Informal document No. GRSP-48-16
(48th GRSP, 7 - 10 December 2010,
agenda item 9)

Explanation of the proposal for Supplement 3 to the 07 series of amendments to Regulation No. 14 (Safety belt anchorages) submitted by the experts from Germany*

Option 2

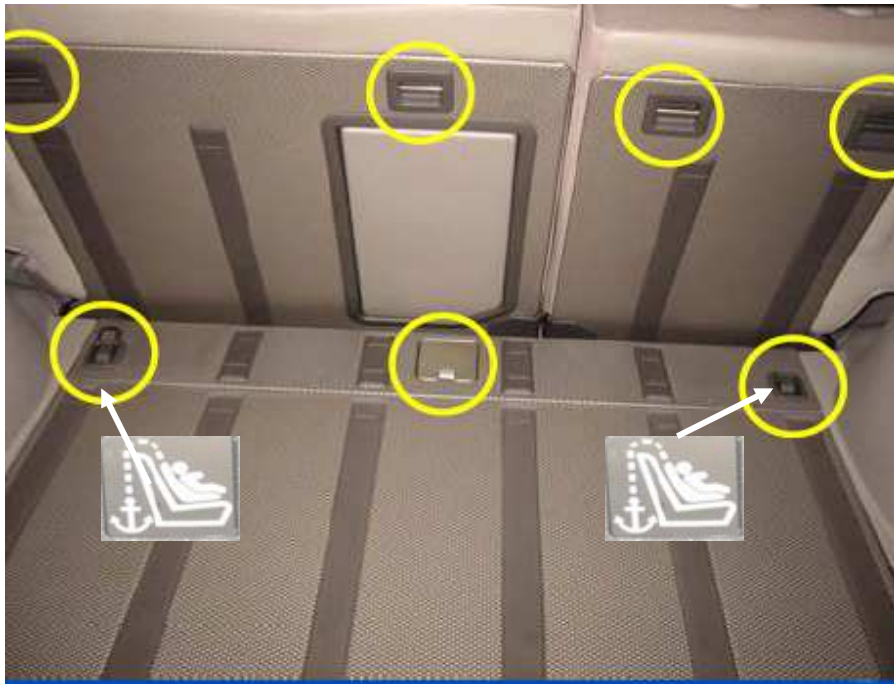
- (b) Marking only the ISOFIX top tether anchorages using one of the symbols, or its mirror image, as set out in figure 13 of Annex 9; or
